## MEMORANDUM

RE: ZP21-0799CA, 157-159 South Champlain Street

**Request:** Construct 5 story Multi-family Large building with 32 residential units on vacant lot.

THE DIAGRAM ABOVE IS AN EXCERPT OF REGULATING PLAN SPECIAL REQUIREMENTS MAP 2 - SPECIFIC HEIGHT AREAS. (SEE SEC. 14.2.6)

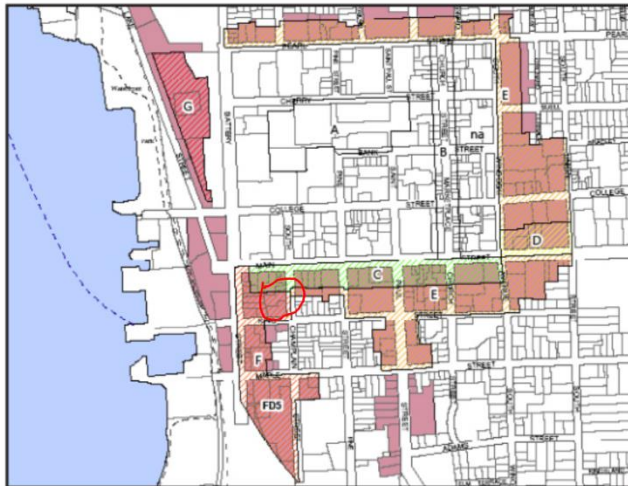
The subject parcel is within the area identified as "F" on Map 2 – *Specific Height Areas* and is

therefore eligible to request of the DRB building height up to 55'. In addition, Section 5.2.6 (b) allows the administrative officer a 5% increase in building height to accommodate changing grades of the site.

The proposed building height is 57', is within the DRB allowance (55') with

consideration of the additional 5% (2.75') allowable per 5.2.6 (b). No additional stories are proposed above the 5 story limitation with DRB approval. See Sections 5.2.6 (b) and 14.6.4 (f) below.
